Groundwater Transfer Review Summary Form

Transfer/PA # T- 14507

Application: T-14507

Applicant Name: Christopher and Anne Ray

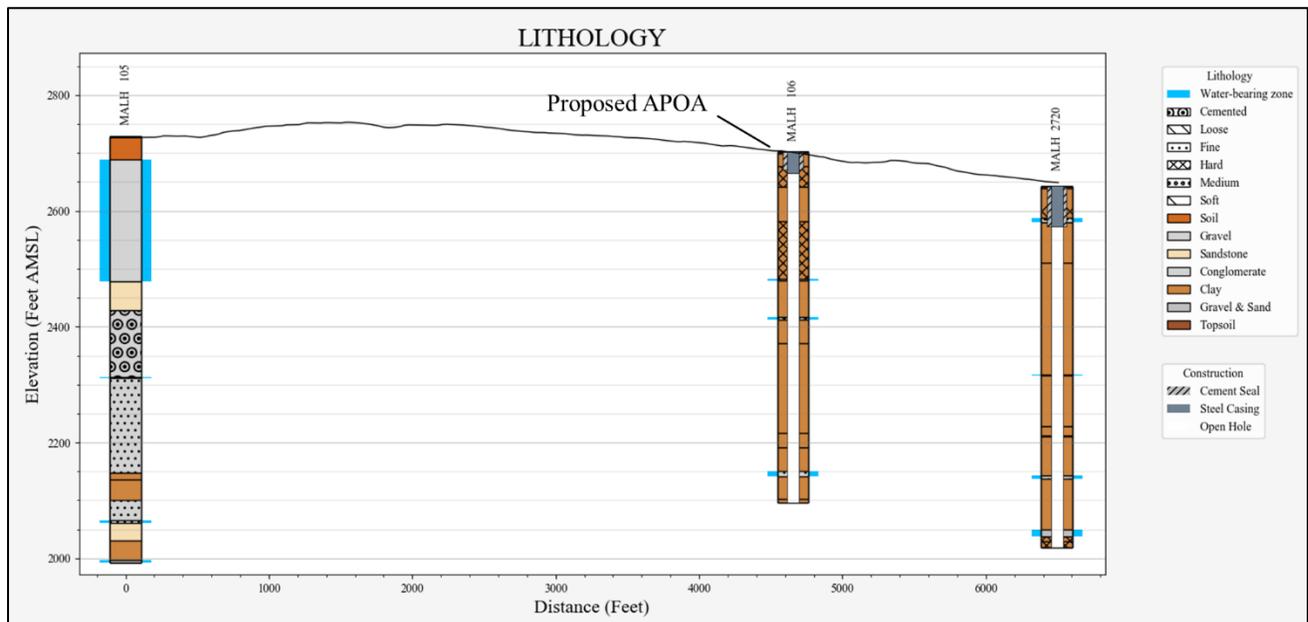
Cross-section A: Both authorized POA wells and the proposed APOA produce from similar depths and lithologies, based upon reported well log descriptions.

Cross-section B: The proposed APOA well reports similar lithologies as wells in the alluvial valley, though nearby MALH 105 reports encountering significantly different materials, likely due to its position above the valley floor in older sediments in a higher energy depositional setting. In either case, there is no evidence of a significant barrier to groundwater exchange between the two sedimentary sequences.
